Subject: email to Parish Council 25 November Minor Amendments Lanes End WA/7/19/RES

Comments on Option Unit 6

A+V 1-12-2019

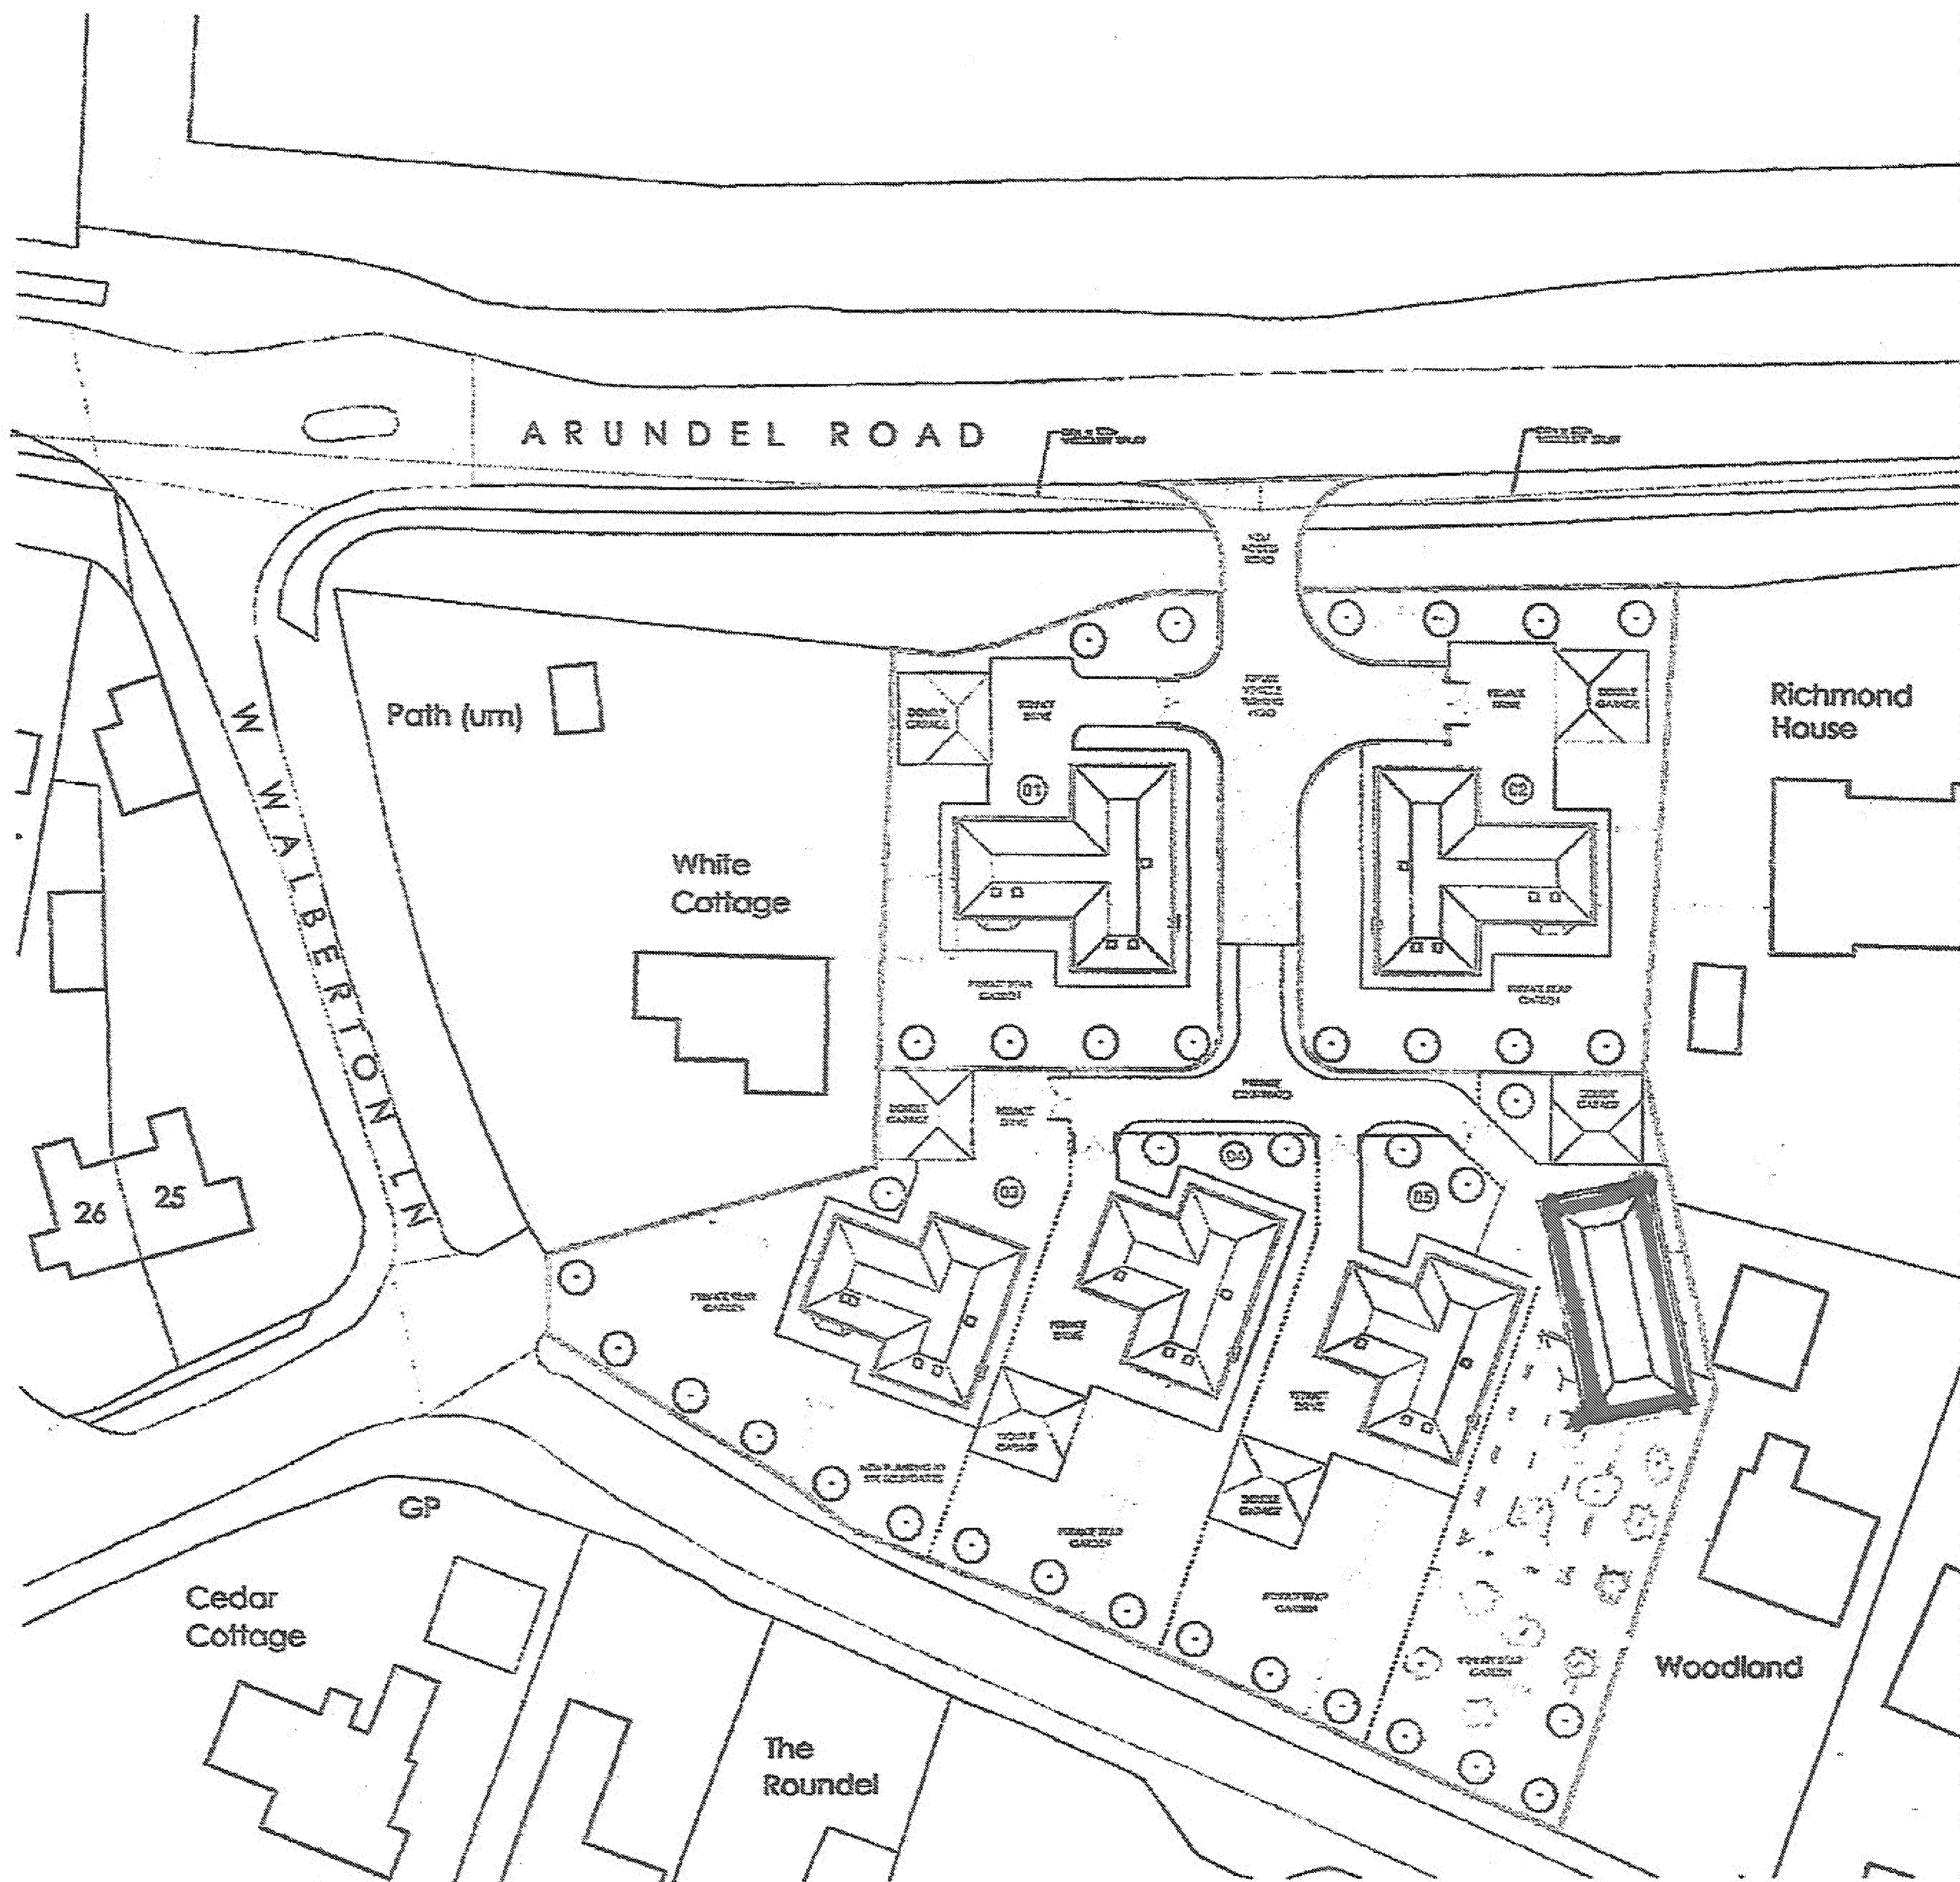
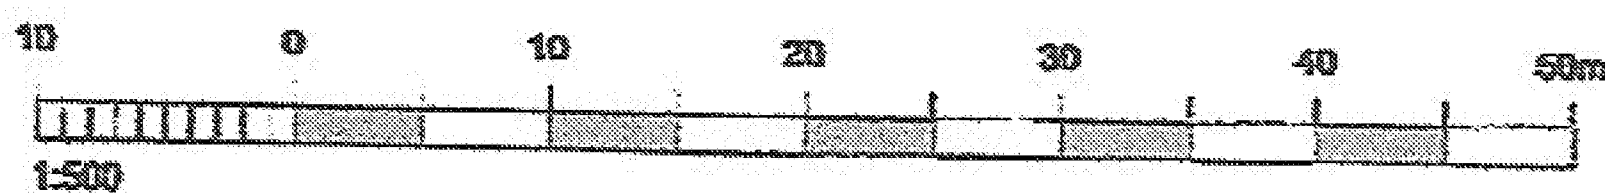
1. The view from Woodland would be badly affected. The existing Lanes End house is c40 metres from the boundary, but the unit 6 is less than 5 metres.
2. The size and closeness of unit 6 would mean a major loss of natural light in Woodland, our house, and would cast a large shadow over Woodland, its patio, conservatory and gardens on sunny afternoons
3. Most unit 6 windows will probably be on the wall facing Woodland, and more than on previous plans. These windows should be obscured glass and non-opening, to protect privacy of Woodland occupants.
4. Surface water run-off from the building will have an immediate effect on Woodland property.

1. The moving of unit 6 south from the outline plan position to the now proposed position shortens the garden length, and will badly affect its use as there are 2 trees with TPOs at the southern end of the plot.

2 Being so close to Woodland house would mean a major loss of privacy in unit 6.

It would be better for everyone to move unit 6 further North and turned slightly as shown on attached drawing A&V dated 1.12.2019 – nearer the position in the approved outline Block Plan. This removes most overlooking and privacy loss in both directions.
